Re: Agenda Item #: 4.b. Ordinance Bill 15-23

Salem Transportation System Plan Amendment Testimony

MAP APPENDIX

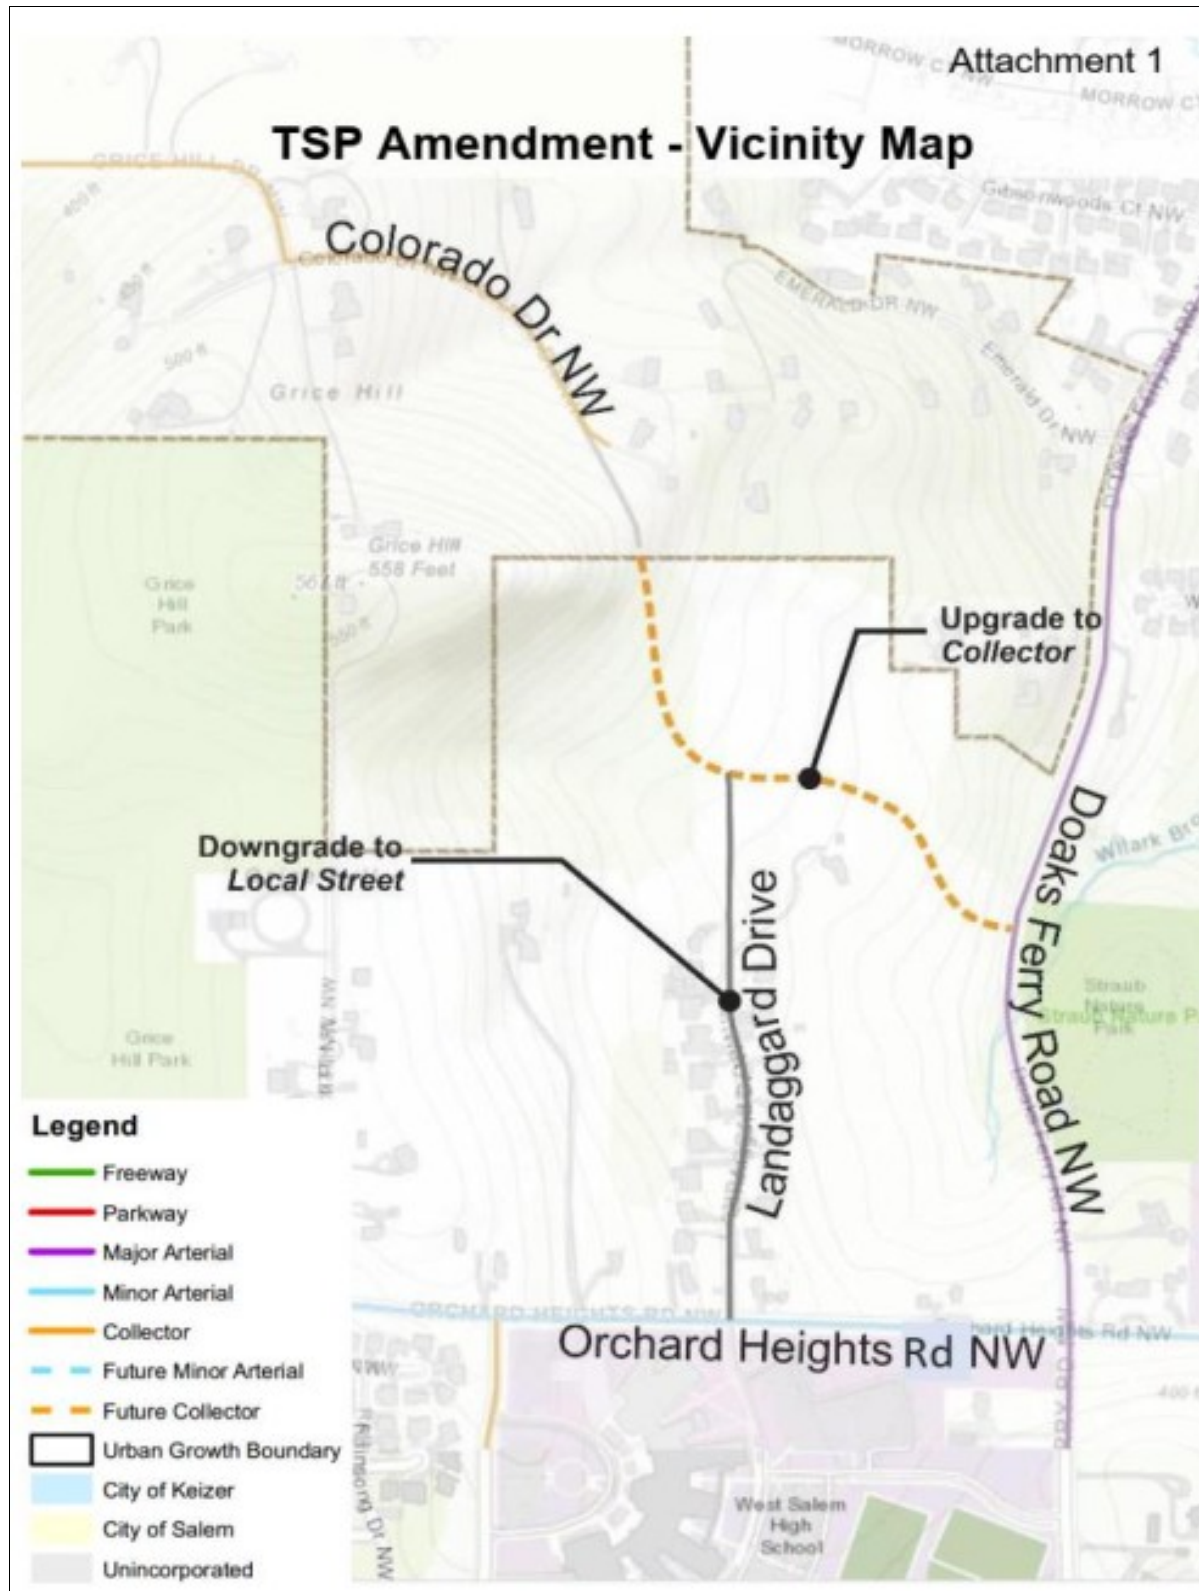
However, I vehemently challenge and ask that you reject the staff proposed alignment of Colorado Drive between the surveyed termination of Colorado Drive at the northern boundary of Tax Lot 500 and the tentatively approved street "A" alignment across Tax Lot 400 to Doaks Ferry Road until the following issues are resolved.

3. The tentative Titan Hill subdivision includes a future Colorado Drive slope greater than 8 percent. Why? Has the Tax Lot 400 owner provided evidence that there are no alignments across the Tax Lot 400 (Titan Hill) topography that will permit Colorado Drive to maintain an 8 percent or less slope between Tax Lot 500 and Doaks Ferry Road?

4. What is the logic of the revised Salem TSP that bisects Tax Lot 500 in such a manner that the northwest corner of that tax lot is isolated from the remaining bulk of Tax Lot 500? Since Salem roadways create new tax lot boundaries, what will happen to the narrow strip of land, approximately 36-feet wide depicted below, in Tax Lot 500 east of Colorado Drive once Colorado is angled southward into TL 500 and subsequently eastward into TL 400 (Titan Hill)?

5. How will the proposed Salem TSP modification implement the transition between the current Colorado Drive 68-foot R-O-W and the proposed TL 400 (Titan Hill) Colorado Drive 60-foot R-O-W?
6. Under what circumstances may the City of Salem adopt and/or modify the Salem TSP that approves a collector street alignment that does not meet Federal ADA transportation facility requirements?

Figure 1. Enlarged segment of Proposed TSP Amendment – Vicinity Map

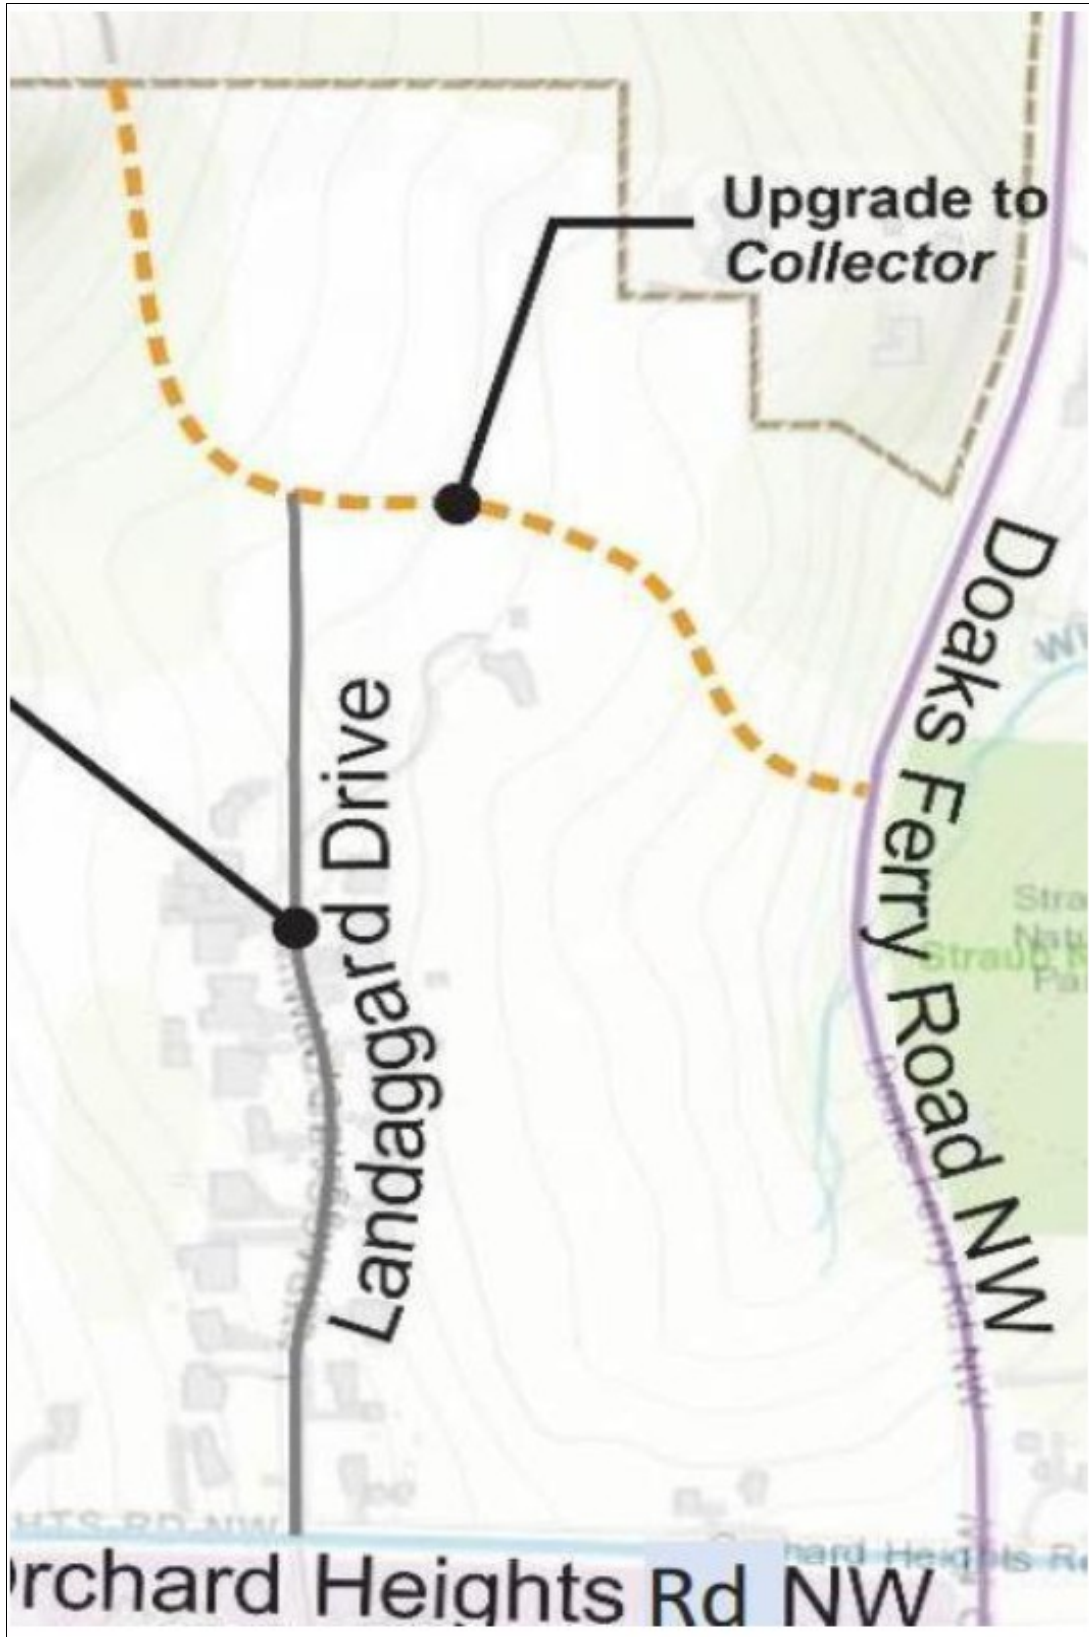
I challenge the Attachment 1 **Vicinity Map** graphic on page 1 for the following reasons.

1. It falsely shows the local street Landaggard Drive extending to the proposed Colorado Drive link (orange dashed line) to Doaks Ferry Road. See and compare Map Appendix Figures 1 and 2,
2. It incorrectly claims Landaggard Drive needs to be downgraded to a local street status.
3. It offers a projected Colorado Drive alignment that does not match street “A” (Map Appendix Figure 6) and fails to meet the 8 percent maximum required by both Federal ADA rules¹ and the Salem Revised Code².

Figure 3. Red line Colorado 8% Alignment on a Polk County ESRI Graphic

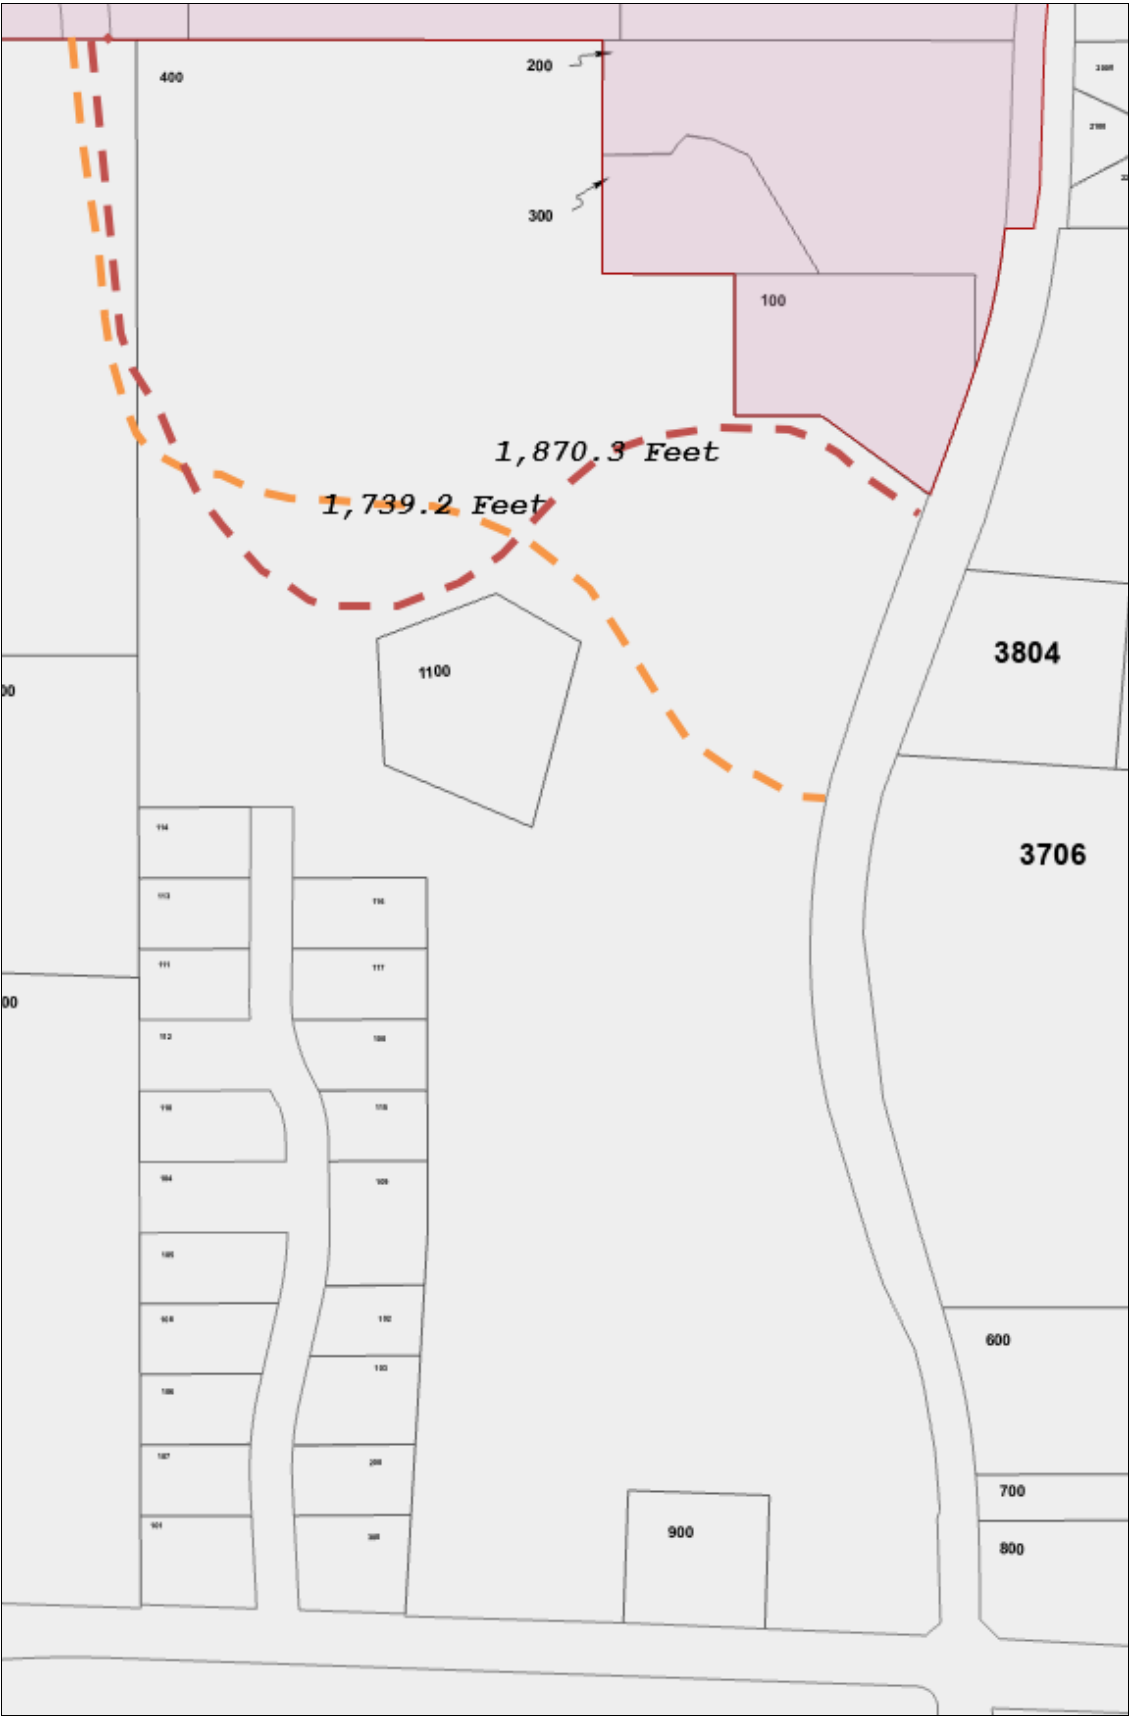
The dashed red dashed line on Map Appendix Figure 3 page offers an eight percent or less Colorado grade to Doaks Ferry Road and the blue dashed line on Map Appendix Figure 5 shows a less than 8 percent grade to Orchard Heights Road.

Figure 4. Blue line Colorado 8% Alignment on a Polk County ESRI Graphic

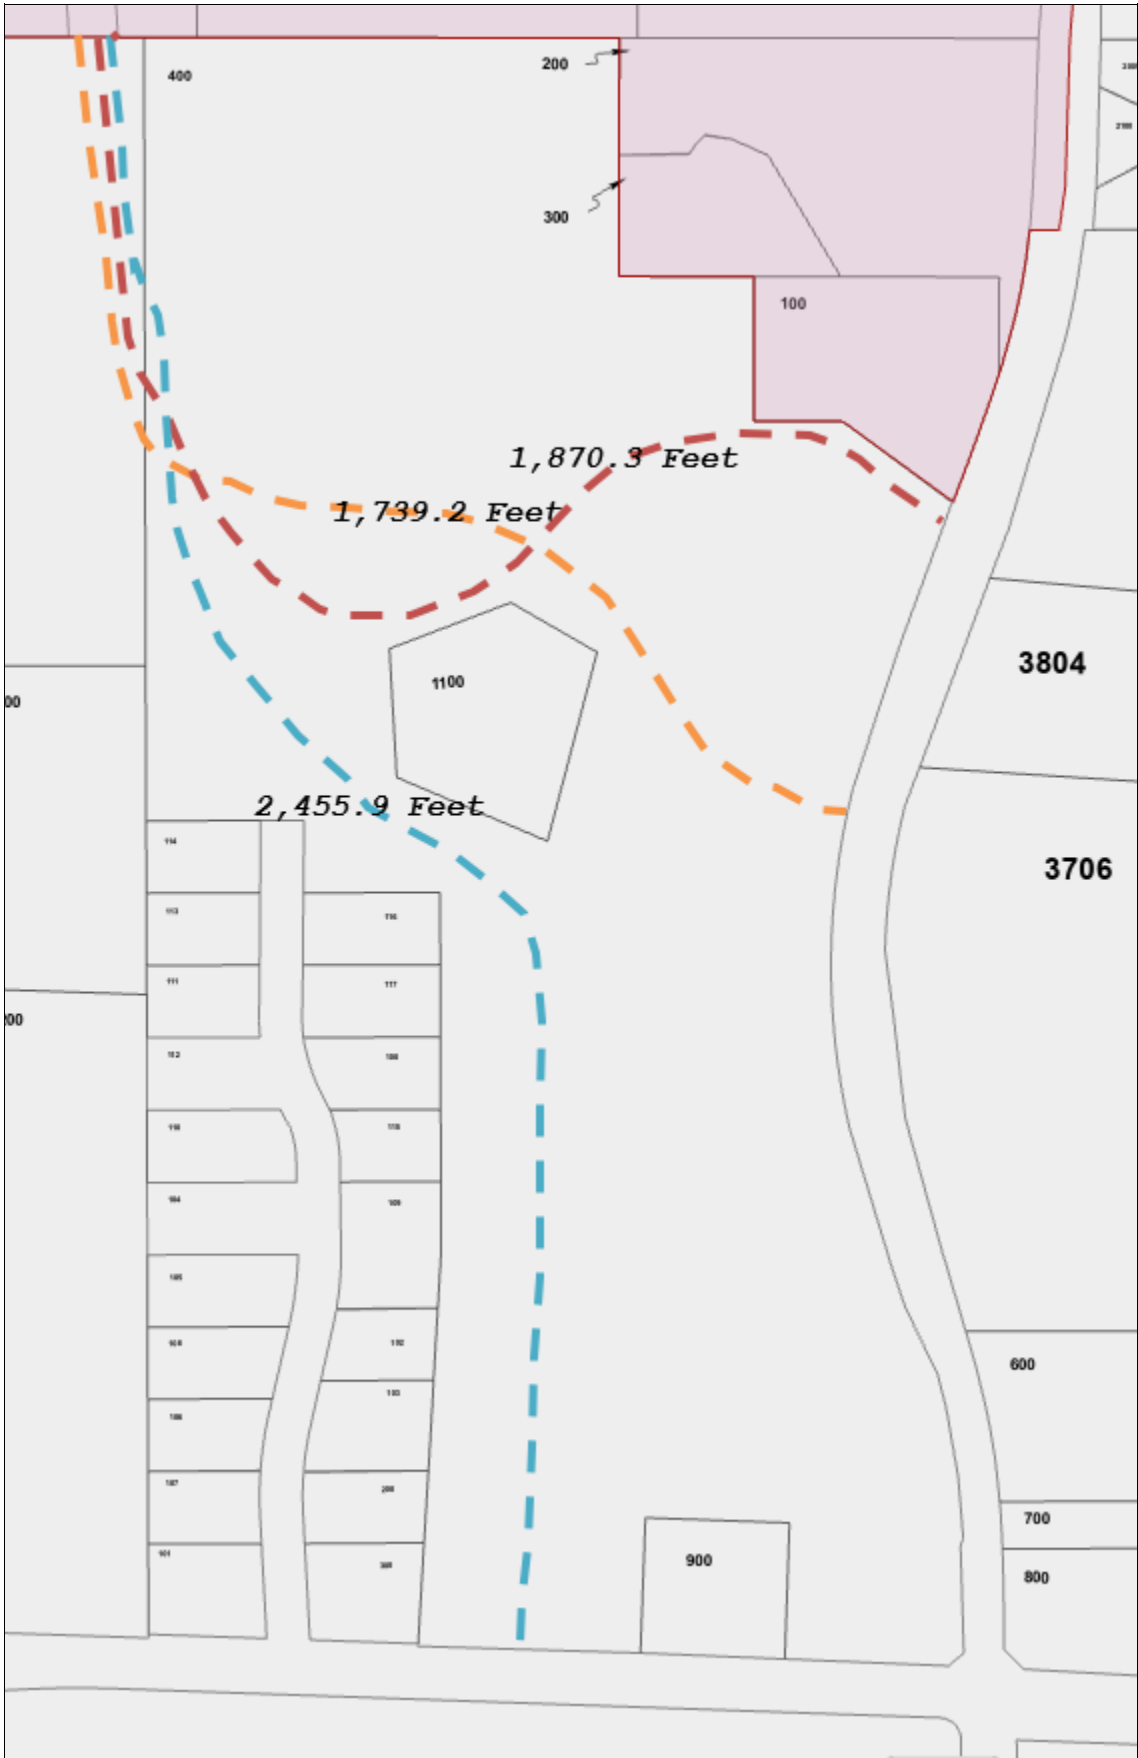
First, to assume that the only possible Colorado alignment to Orchard Heights Road is via Landaggard Drive is inaccurate. The dashed blue line Figure 4 offers an alternative connection between Colorado and Orchard Heights that is not considered in the materials submitted to Council.

Tentatively Approved Titan Hill Subdivision Proposed Colorado Drive Conflicting Alignments

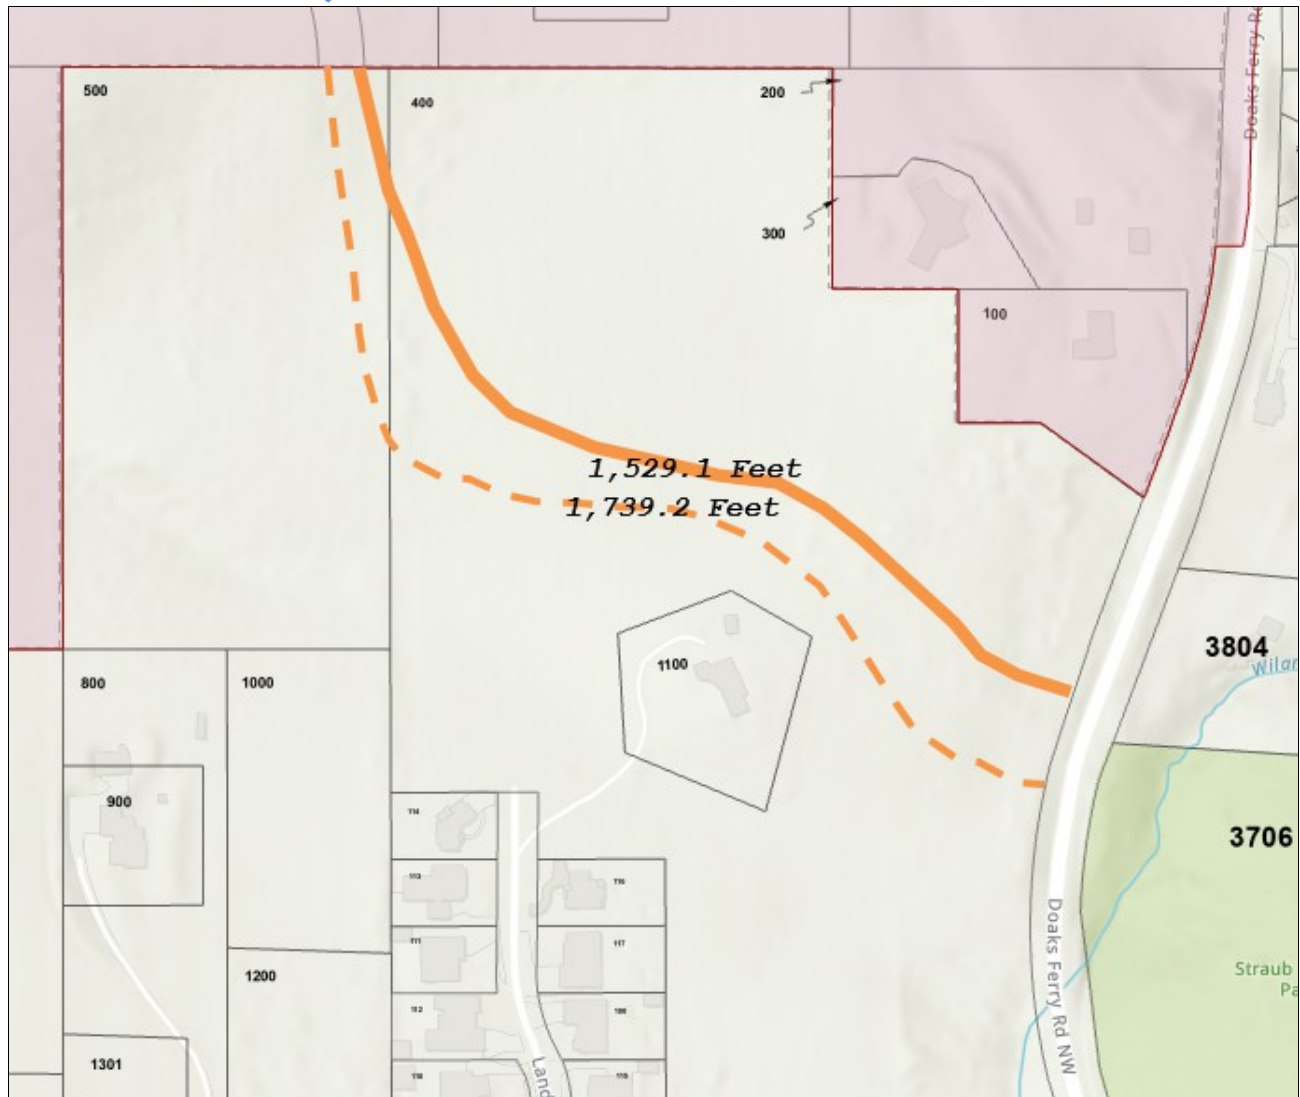
Solid Orange Line – Approximate alignment of Street “A” in the tentatively approved Titan Hill Subdivision. See Map Appendix Figure 6.

Dashed Orange Line – Approximate alignment of the future collector street Colorado Drive shown on **TSP Amendment - Vicinity Map**. See Map Appendix Figure 1.

- Which one of the two alignments will the Council's approval of the Salem Transportation System Plan (TSP) amendment becomes the actual approved Colorado Drive alignment?
- Will the approved alignment meet all Salem TSP legal requirements?

Figure 6

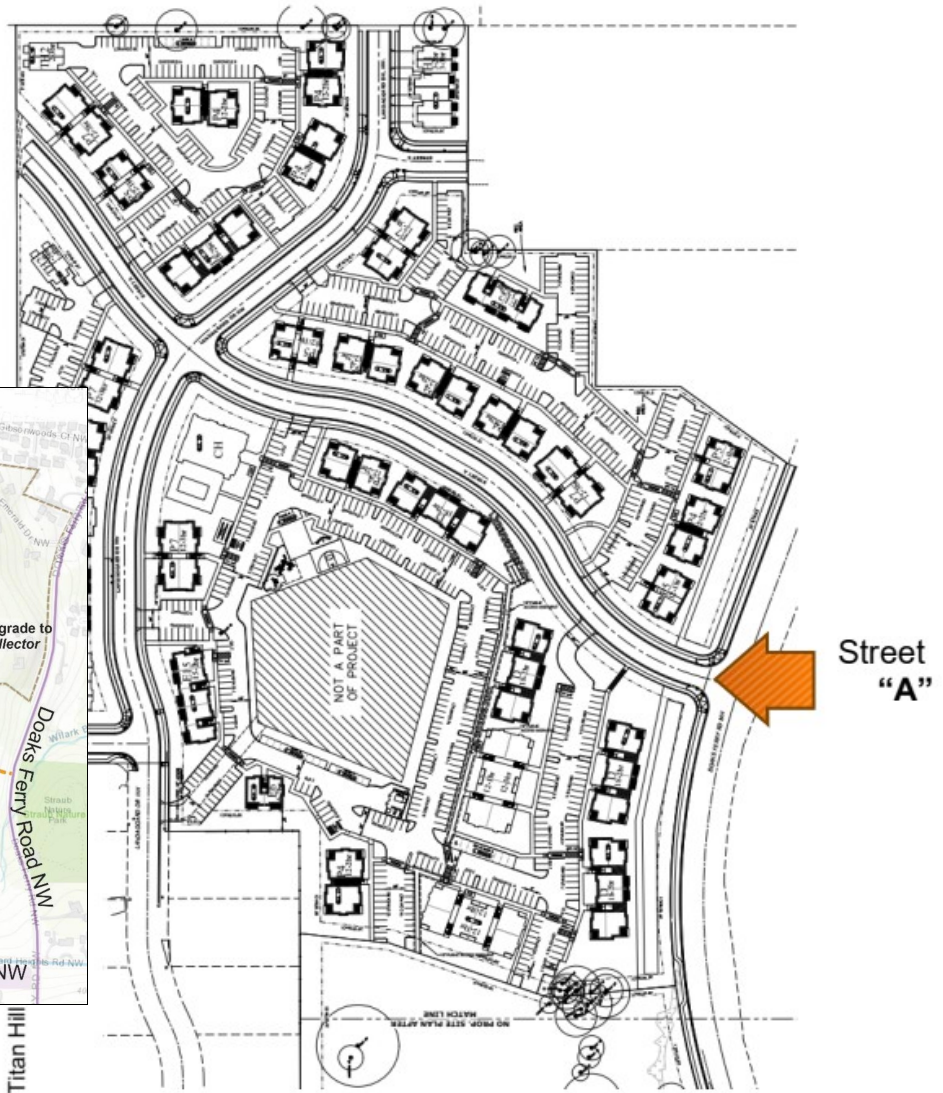
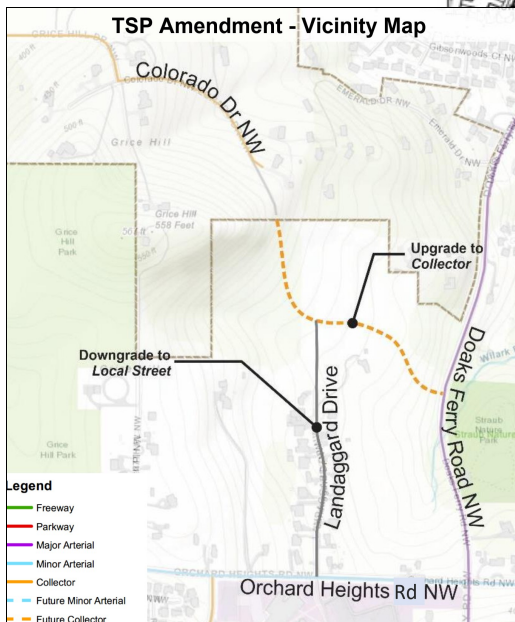
Note: Street "A" does not connect to the surveyed but not built Colorado Drive which terminates at the northern border of TL 500.

Note: The Titan Hill development is responsible for JUST the construction of Street "A" / Colorado Drive up to the border of Tax Lot 500. When and who will be responsible for completing the final connection to Colorado Drive remains unanswered.
